Reviewer 1

Reviewer 2

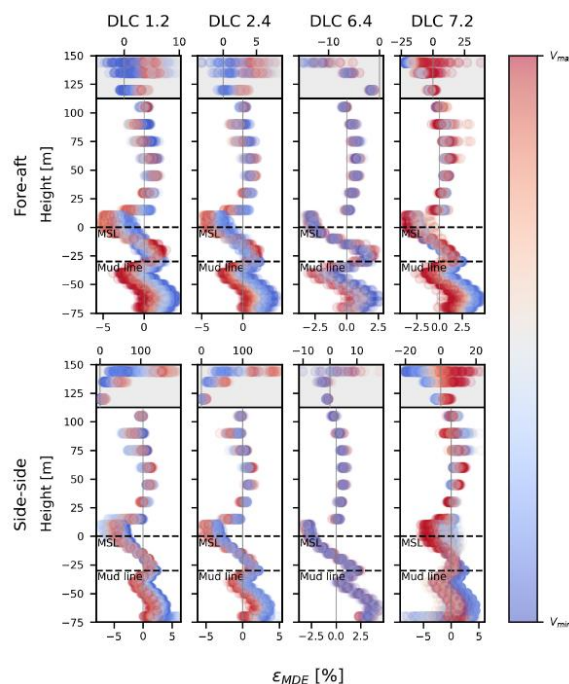
RC2.23 (Figure 14) As per the introduction of the paper, the levels below MSL might be the ones with difficult accessibility and thus the ones where MDE might be more useful. However, in this figure, the large error at TT cloud the understanding of the errors at lower levels. Would it make sense to split the figure to allow two x-axes?

RC2.23) Thank you for bringing this to our attention. It is indeed difficult to assess the errors at lower levels, and a good idea to split the figure. The figure has been corrected according to this comment as:
